Reply to the comments of referee #1

The title has been changed to “*Experiences and Lessons Learned from Designing and Testing of an Air System and a Drilling Fluid Circulation System Adapted for Subglacial Bedrock Drilling in Antarctica*”. In the new title, the “experiences and lessons” is emphasized, and the two systems are emphasized to be used for subglacial bedrock drilling in Antarctica.

Reply to the comments of referee #2

Figure S1. Flow rate and pressure of drilling liquid required in ice drilling (a) and subglacial bedrock drilling (b)

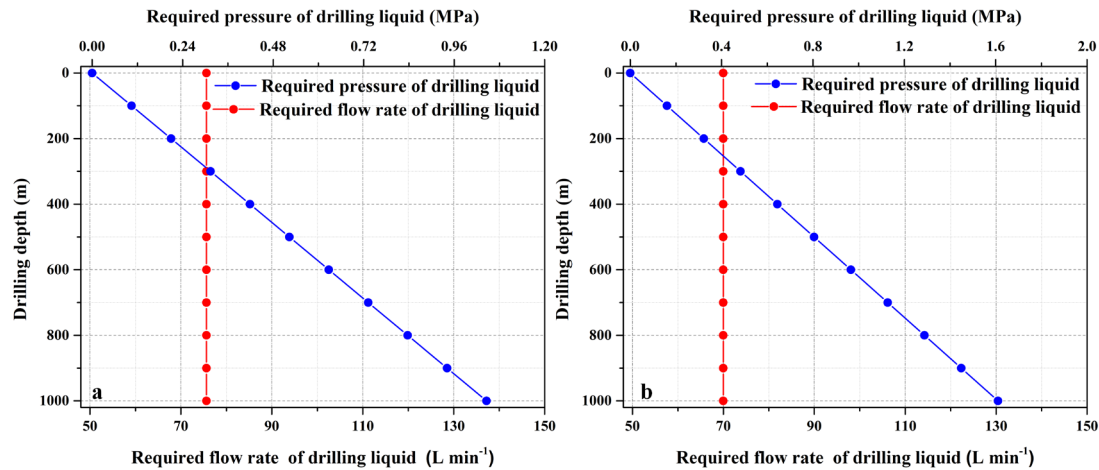
L257-258. Refereeing to Alemany et al. (2021) in order to choose flow rate and pressure required for ice and subglacial bedrock drilling is incorrect method because borehole depth, diameters of

drill pipes and bits are absolutely different. Authors should provide their own estimation of surface pump requirements.

L261. Why 2 MPa. Reference?

We only use the method provided by Alemany et al. 2021, instead of choosing the flow rate and pressure according to their results. Our estimation is based on the type of drilling liquid, borehole depth, borehole diameter, and drill-rod size. The details of the estimation are as following.

The flow rate and pressure of drilling liquid required in ice drilling and subglacial bedrock drilling can be calculated according to Alemany and others (2021). In the calculation, the penetration rate is also set as 100 m/h, while the concentration of ice chips is assumed to be 0.025. Kerosene JET-A1 is assumed to be drilling liquid. The drilling fluid are considered to be at the temperature of -30°C , which has a density of 846 kg/m^3 and a viscosity of $5.29\times 10^{-6}\text{ m}^2/\text{s}$ (Talalay and Gundestrup, 2002). The safe factor of pressure is set as 1.5. In both ice drilling and subglacial bedrock drilling, the maximum drilling depth is considered to be 1000 m. It is worth to be mentioned that liquid reverse circulation is used in ice drilling while liquid normal drilling is used in subglacial bedrock drilling.

As shown in the following Fig. S1, the required flow rate keeps constant with increased drilling depth. In our case, the flow rate is about 76 L/min. However, the required liquid pressure during ice drilling increasing linearly with drilling depth increasing. In a 1000 m borehole, the required liquid pressure can be more than 1.0 MPa. The required flow rate and pressure in subglacial bedrock drilling has the same variation trends as in ice drilling. To obtain bedrock sample below 1000 m ice, the required flow rate is less than 70 L/min and the required pressure is about 1.6 MPa. To ensure the ability of the drilling-fluid pump, it is expected to have a rated flow rate of 100 L/min and maximum pressure of the 2 MPa.

As mentioned above, the estimation of the flow rate and pressure needs the type of drilling liquid, borehole depth, borehole diameter, and drill-rod size. The detailed information will be provided in our coming paper about the whole MPDS, including the calculation process of flow rate and pressure. In the study, we focus on the design and test results of the drilling liquid circulation system, so the estimation is not contained in the manuscript.
